# BOSEM Noise Analysis

## Analysis of BOSEM Performance per "Sensors and Actuators for the Advanced LIGO Mirror Suspensions" P1100208

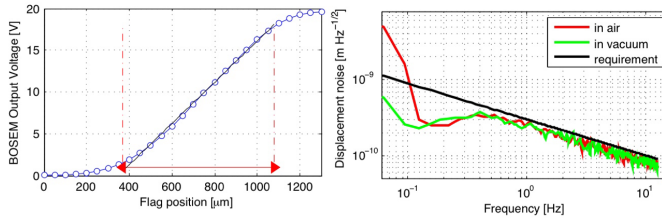
✓ TYP0 Per Figure 6, the BOSEM sensitivity should be:

$9 \times 10^{-10} \frac{m}{\sqrt{Hz}}$  @ 0.1 Hz  
 $3 \times 10^{-10} \frac{m}{\sqrt{Hz}}$  @ 1 Hz  
 $1 \times 10^{-10} \frac{m}{\sqrt{Hz}}$  @ 10 Hz

$V_{out}$  at  $\frac{1}{2}$  light =  $\sim 8.5 VDC$  per Figure 6

Ⓟ Per page 6, measuring range =  $\sim 700 \mu m$ , and the average slope of Voltage output VS position is  $\sim 20 \frac{kV}{m}$  (actual  $\frac{16V}{700 \times 10^{-6} m} = 22.9 \frac{kV}{m}$ )

Ⓟ Per page 6, the BOSEM noise performance should be limited by shot noise at  $7 \times 10^{-11} \frac{m}{\sqrt{Hz}}$  for Freq > 10 Hz. Freq < 10 Hz, the performance should be limited by  $\frac{1}{f}$  photo current noise in the LED

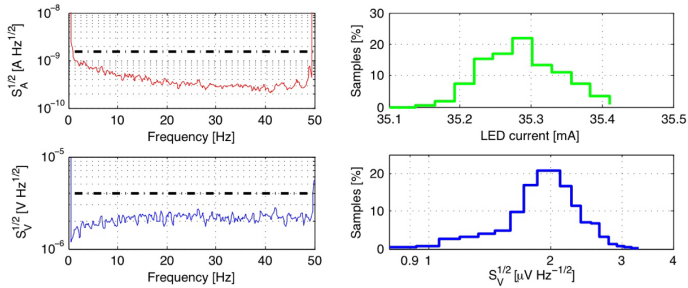
Per page 9, the LED current source produces 35 mA for each LED with  $\frac{0.5 \text{ nA}}{\sqrt{1\text{Hz}}}$  at 10 Hz corresponding to  $3 \times 10^{-11} \frac{\text{m}}{\sqrt{1\text{Hz}}}$  which should be  $\sim 3X <$  the requirement

② Verified  $I_{\text{LED}}$  noise @ 10 Hz per figure 8 is  $\leq \frac{0.5 \text{ nA}}{\sqrt{1\text{Hz}}}$  @ 10 Hz

\* measured aLIGO unit  
 current noise to be  $0.7 \text{ nA}/\sqrt{1\text{Hz}}$  @ 10 Hz  
 S1000276 Unit from LHO  
 BOSEM Pedigree unknown
